RE: Volcano Cliffs Subdivision Lot 7 Block 8 Unit 18 6509 Canavio Pl NW Grading and Drainage Plan **Engineers Stamp Date 1/30/17 (D10D003O7)**

GRADING AND DRAINAGE PLAN

LOT 7, BLOCK & JUNIT 18, VCS

#### **Narrative**

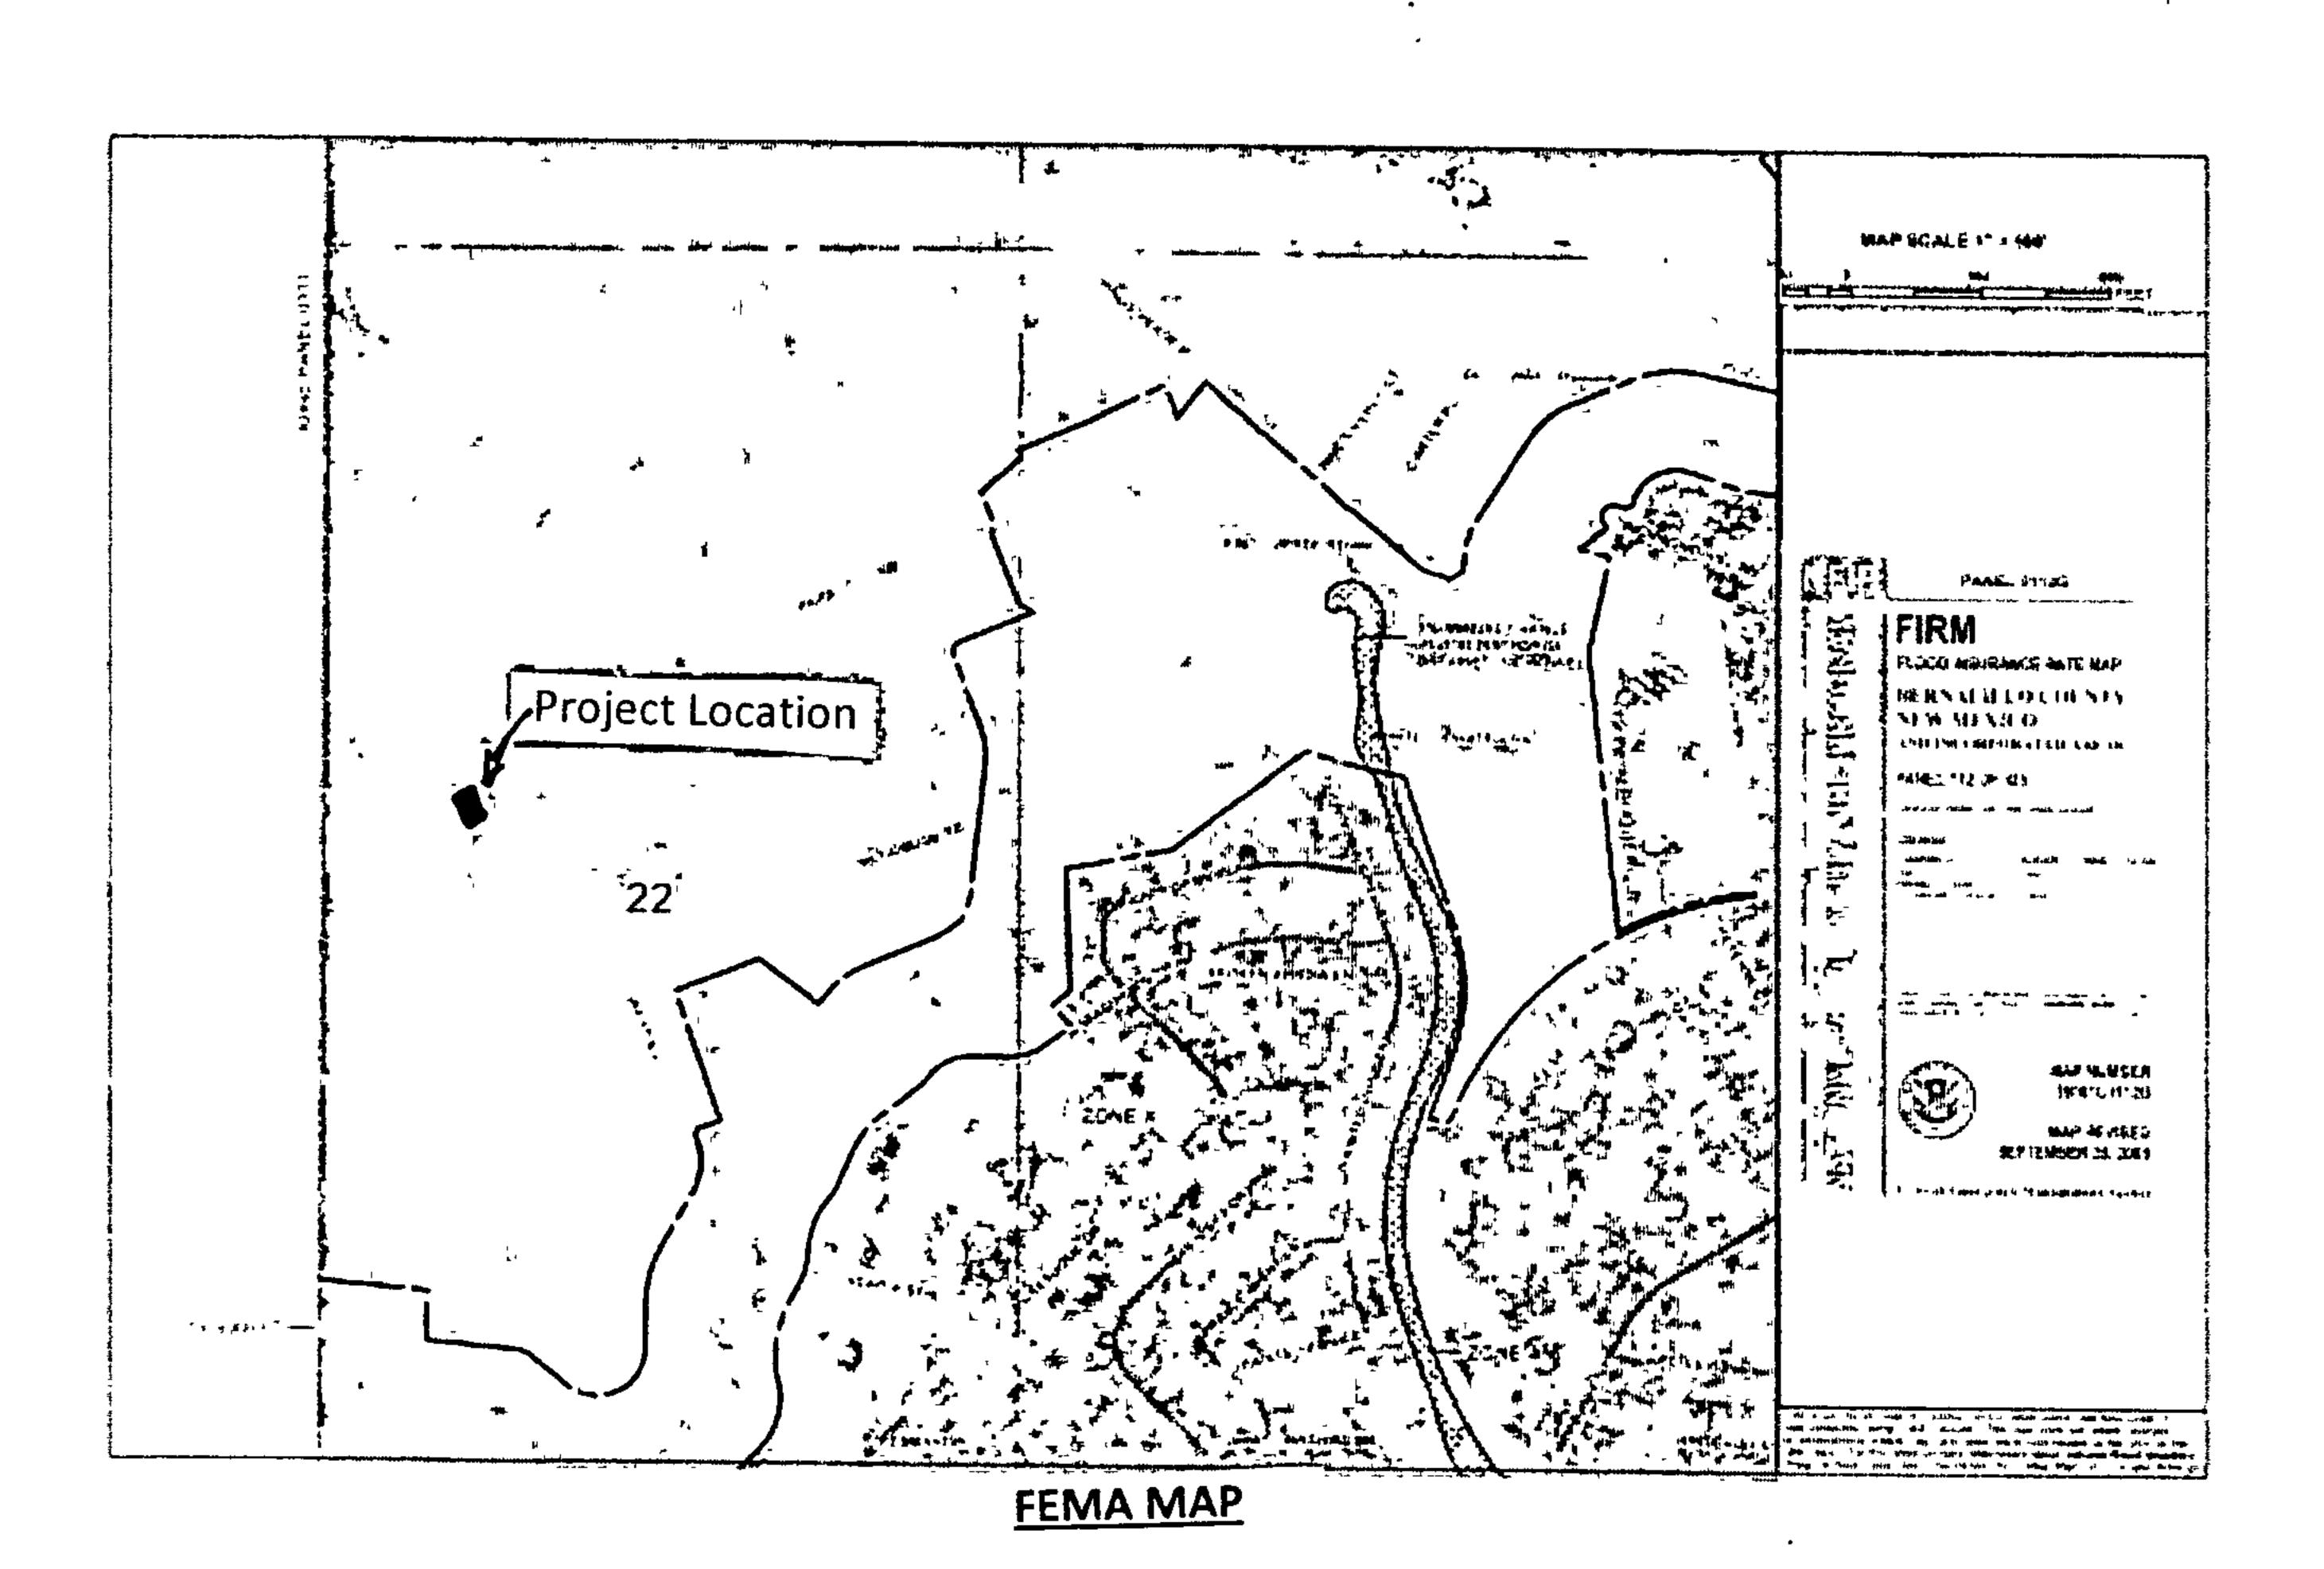
Based upon the information provided in your submittal received 1/17/17, the above referenced Grading and Drainage plan dated 1/17/17 cannot be approved for Grading Permit until the following comments are addressed:

- Provide a note stating that future garden walls require a separate permit and this plan should be used for their placement.
- Provide a statement that a pad certification is required before a building permit is given.
